ACCESSION NBR:9910050132    DOC.DATE: 99/09/24    NOTARIZED: NO    DOCKET #  
FACIL:50-244 Robert Emmet Ginna Nuclear Plant, Unit 1, Rochester G 05000244  
AUTH.NAME                AUTHOR AFFILIATION  
MECREDY, R.C.           Rochester Gas & Electric Corp.  
RECIP.NAME               RECIPIENT AFFILIATION  
VISSING, G.S.

**SUBJECT:** Forwards more detailed response re main steam check valve performance questions arising from NRC Insp 99-05 following completion of assessment being performed by Duke Engineering & Services.

Subject: Response to Questions Related to Main Steam Check Valve Performance per  
NRC Inspection 99-05

FIGURE 1 - SG PRESSURE

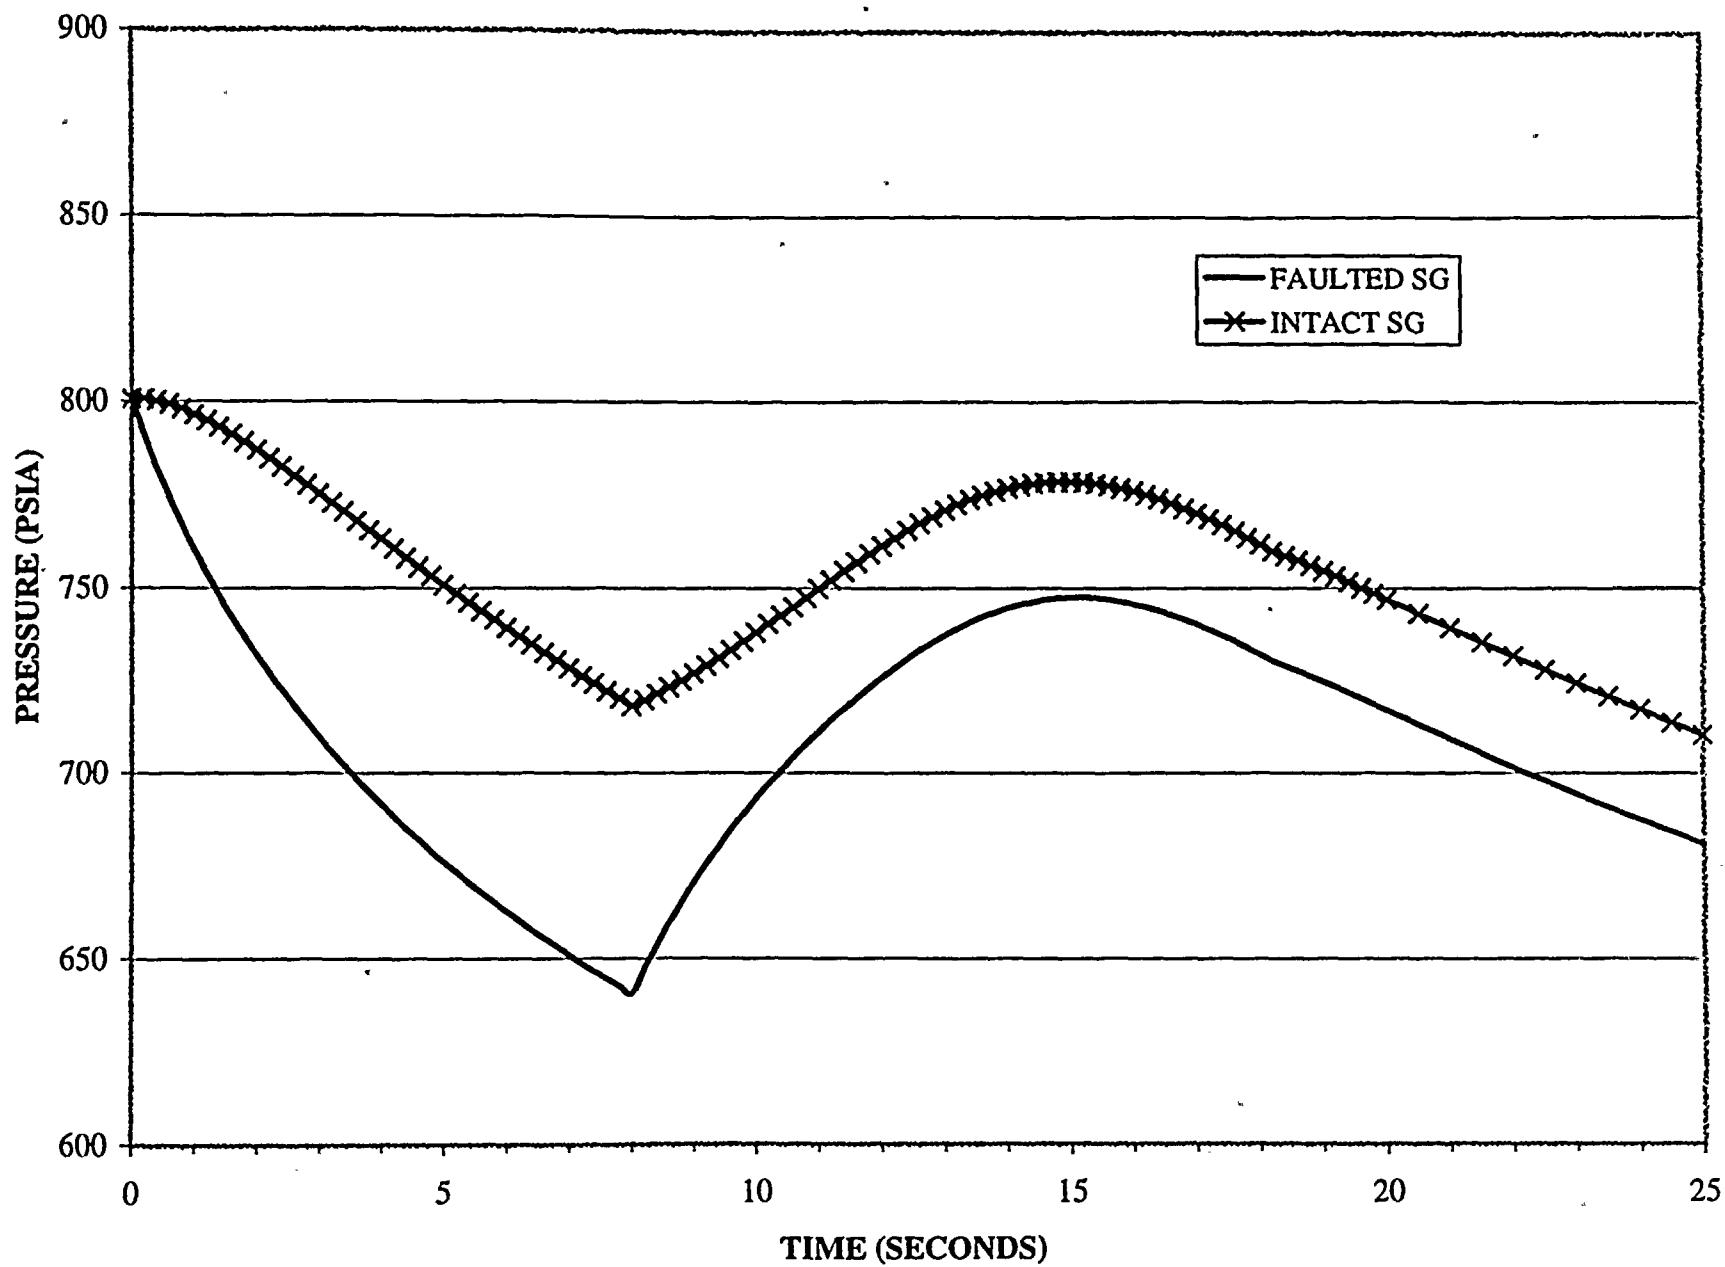
What analysis method will be used? It is felt that a 3-dimensional computational fluid dynamics code is needed to properly model the complex flow conditions. How will the analysis performed be validated for this type of application?

To demonstrate this condition, a revised LOFTRAN analysis was performed in Reference 3 that more closely modeled the reverse flow transient for mass flow from the intact SG to the break location. The Reference 3 analysis also used a more conservative assessment of MS piping hydraulic resistance to minimize reverse flow from the intact SG. The resulting transient SG pressures for the limiting 0.86 ft<sup>2</sup> steam line break is shown in Figure 1. The resulting transient mass flow rate contribution to the total break flow from each SG is shown on Figure 2.

The Figure 2 results indicate that no reverse flow exists through the MS check valve until after the turbine stop valves have closed. Prior to the closure of the turbine stop valves, all of the break flow is supplied from the faulted SG. After the turbine stop valves have closed, the break area represents the only flow path available for both the faulted and intact SGs. Consequently, reverse flow is initiated from the intact SG to the break location immediately following the isolation of flow to the turbine. The transient flow distribution to the break from the two SGs is a function of the individual SG pressures and the hydraulic resistances for the two flow paths.

Due to the more rapid de-pressurization of the faulted SG prior to the turbine stop valve closure, the intact SG pressure is higher than the faulted SG. This pressure difference causes a surge of flow from the intact SG to the break immediately following the stop valve closure as the difference in SG pressures adjust to the new flow network represented by the closed stop valves and the break. If the initial surge did not close the check valve, the differences in SG pressure would decrease and the flow from the faulted SG would increase while the flow from the intact SG decreases until a new quasi-equilibrium condition exists as shown in Figures 1 and 2.

In reality for this smaller steam line break, reverse flow through the check valve from the "intact" SG would not occur until after the Turbine Stop Valves have closed terminating flow from the two SGs to the Turbine. This would occur after 1 second in time. This has been demonstrated by the transient flow and pressure results provided for the response to Question 1 (Figures 1 & 2).

FIGURE 2 - BREAK FLOW DISTRIBUTION

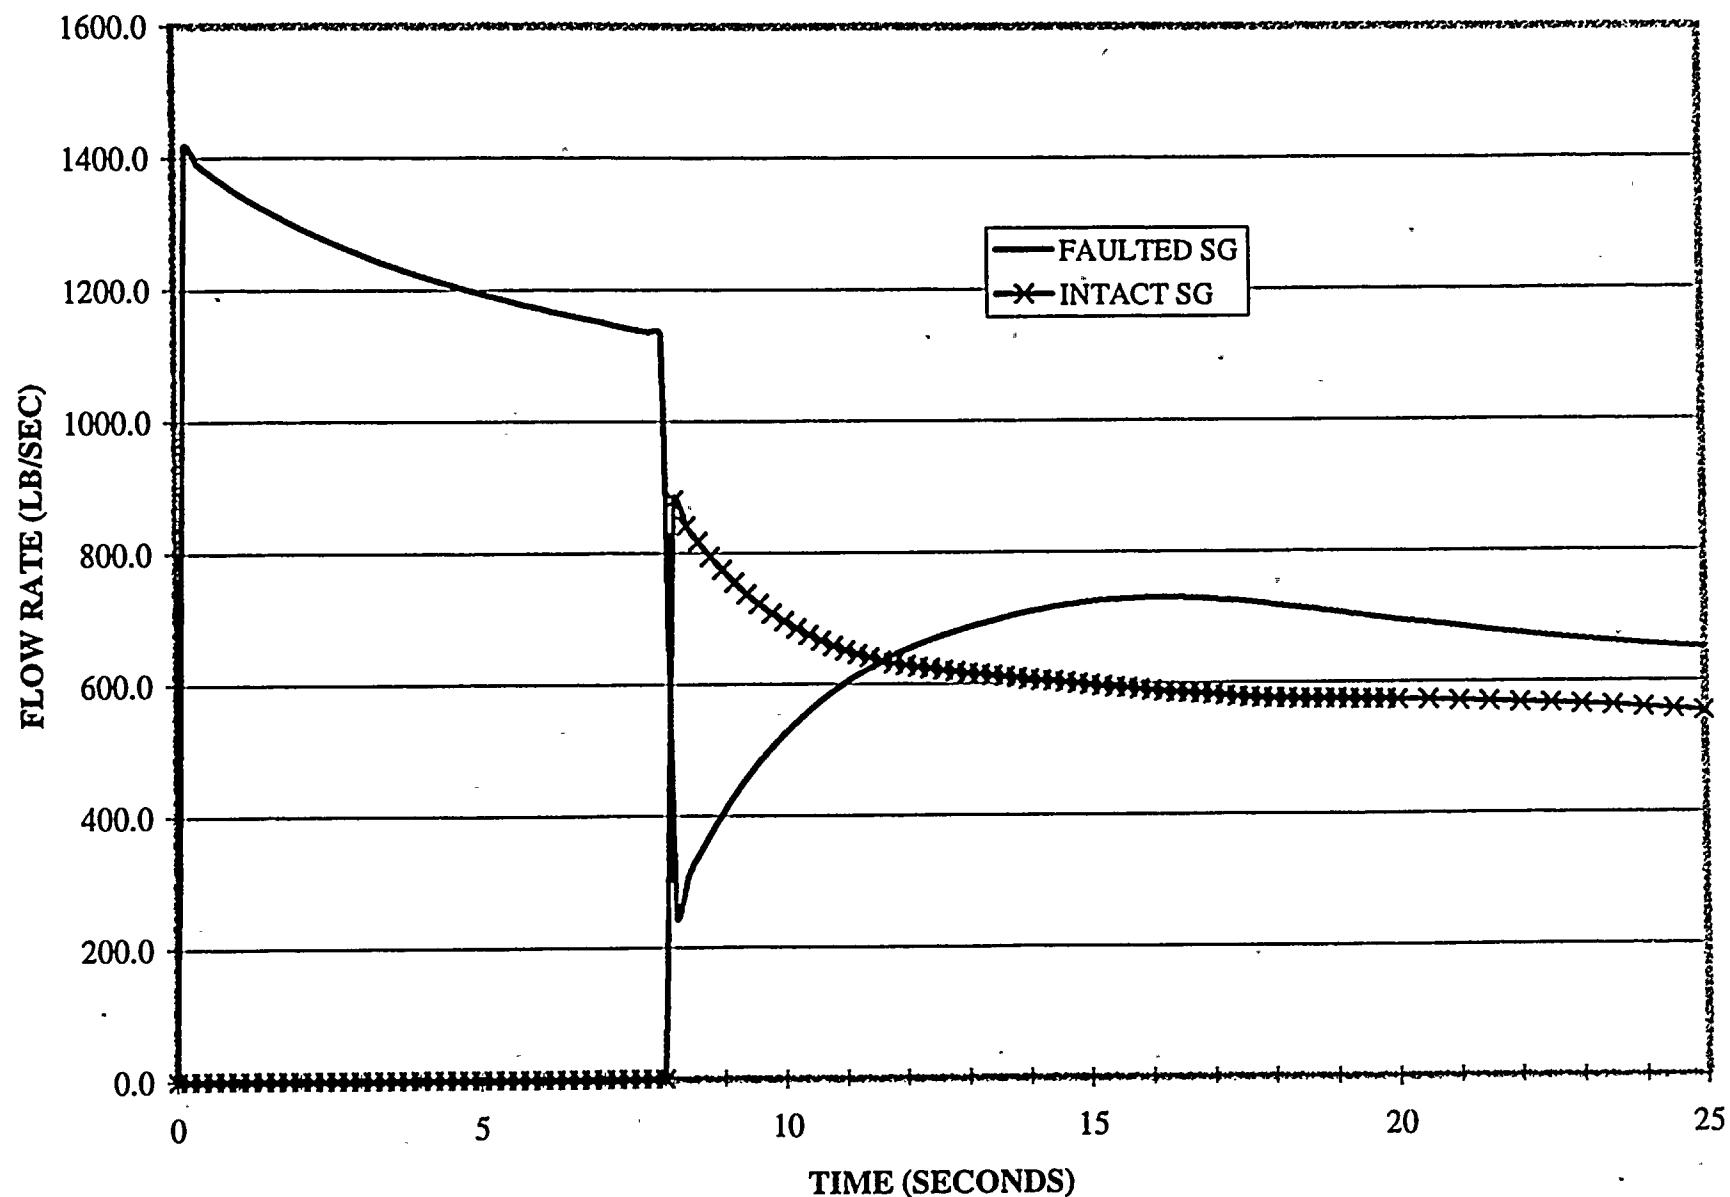
How was the mass flow rate coming from the "line break" SG considered in the calculation of the 603.3 lbm/sec coming from the "operational" Steam Generator?

The maximum reverse check valve flow shown in Figure 2 is approximately 46 % higher than the flow rate used in the Reference 1 analysis. This higher flow indicates that appreciable margin exists with the Reference 1 calculated torque. Using the

Although the DE&S alternate methods calculated lower torques at 603 lb/sec than was used by RG&E in Reference 1; DE&S identified that the torque developed by the actual transient flow shown in Figure 2 resulted in maximum torques well in excess of the 912 ft-lb value calculated by Reference 1. Actual torque margins based upon transient flows ranged from 43 % to 91 % for the two alternate methods. Additionally, DE&S stated that the rapid increase in reverse flow experienced by the check valve would result in a transient impact loading on the valve packing that would cause valve movement at a lower torque than would be developed during normal valve torque testing. Based upon the large flow margin available between the flow used by RG&E in Reference 1 and the actual transient flow shown in Figure 2, DE&S concluded that the fluiddynamic forces experienced by the check valve would be sufficient to close the check valves when experiencing the transient flow rates shown on Figure 2.

The flow rate out of the break at any point in time is determined based upon choked flow, the break size and the local steam line pressure at the break location. The break flow is fed by flow that reaches the break from both SGs after the turbine stop valves have closed. Consequently, the break flow represents the summation of the two individual flow paths. The transient flow rates for the two flow paths that supply the break are shown in Figure 2.

Prior to closure of the turbine stop valves, the flow rate exiting the faulted SG exceeds the break flow (i.e. a portion of the steam flows to the turbine). Therefore, all of the flow out of the break is supplied by the faulted SG up to the time that the turbine stop valves close. No flow from the intact SG reaches the break until after the turbine stop valves close. The 603.3 lb/sec value used in the determination of valve closure torque under reverse flow conditions was chosen to be a conservative assessment of the reverse flow conditions that would exist for the check valve.
